Subject: Caldor Comments on May 4, 2004 Draft Report entitled "Report of the Ultrasonic Flow Meter Allegation Task Group Review of Caldor Ultrasonic Flow Meters"

Caldon's Comments on
NRC Draft Report of the Ultrasonic
Flow Meter Task Group, dated May 6, 2004

**REPORT OF THE ULTRASONIC FLOW METER
ALLEGATION TASK GROUP REVIEW OF
CALDON ULTRASONIC FLOW METERS**

Figure 3. Illustration of Velocity Profile 60 Pie Diameters Downstream of Elbow

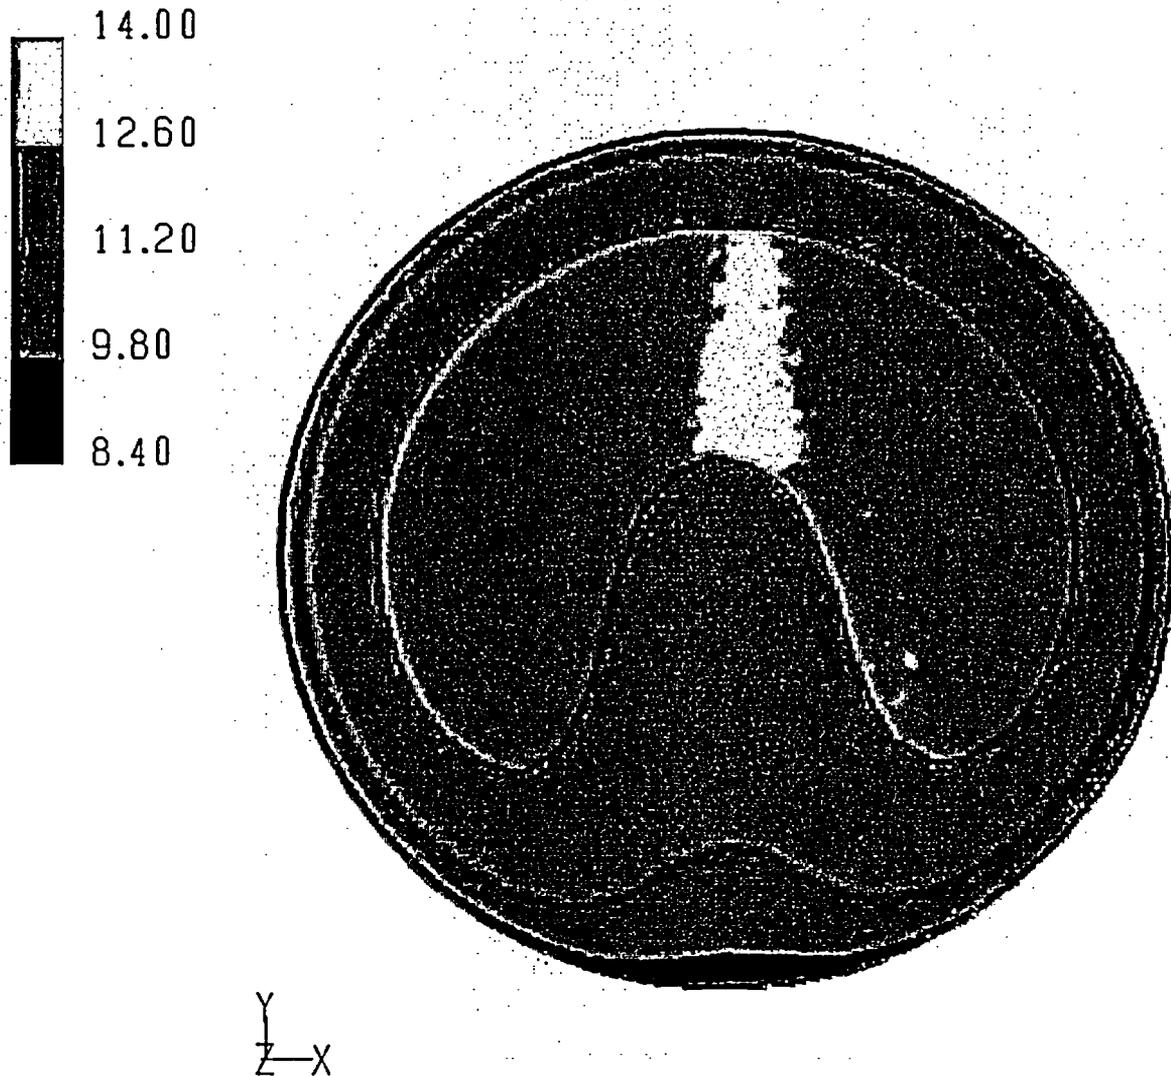
Line	Revision
99	Designation Column – “External LEFM (Several Design Generations)” Task Group Comments Column – change “one” to “two diametral and two diagonal velocities.” delete “velocity”
100	Task Group Comments Column – add “chordal”
101	Task Group Comments Column – add “chordal”
108 & 109	Comments column – delete “ – to be accomplished quarterly starting now.” add “(Quarterly reporting began in 2003)”
112	Comments column – add “Scale model parametric testing simulating plant configuration for External LEFM.”
114 & 115	Revise sentence to read as follows: “In general terms, these instruments effectively measure average flow velocities corresponding to the number and location of sonic sampling paths.”
118	Add following sentence after <i>calibration</i> : “The sensitivities to these deviations is also affected by the numbers and location of the sonic sampling paths.”
128 & 129	Designation Column - “External LEFM (Several Design Generations)” Sonic Paths Column – “2 diametral & 2 diagonal”
